This document comprises only images taken from the applicant's (L&Q) own planning application submission. We have simply re-arranged the images to give a more honest and realistic impression of what the scheme would mean to the area.

We now reproduce some of the submitted drawings, which were presumably sent to the council to try and promote the scheme. They do the exact opposite. The architects have not designed large scale housing before and it shows. These buildings are proposed in a low rise area and which is by their own admission suburban. What's suburban about the following images?

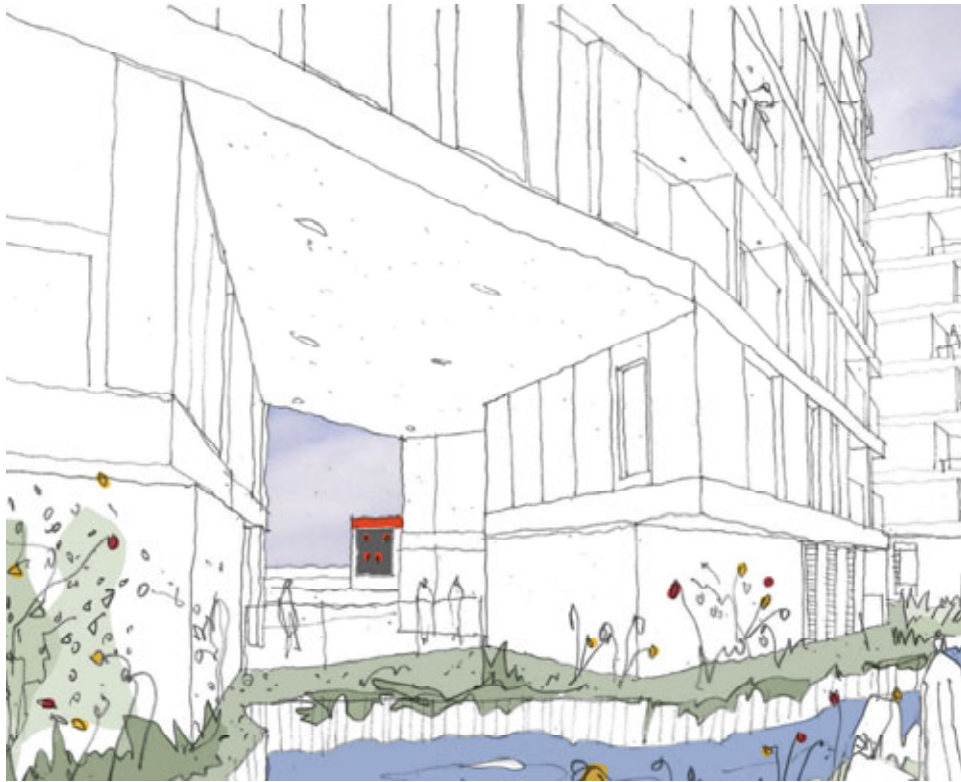
Below; L&Q's 'vision' (which has the sun shining from the north in an attempt to brighten it up a bit...doesn't really does it?)
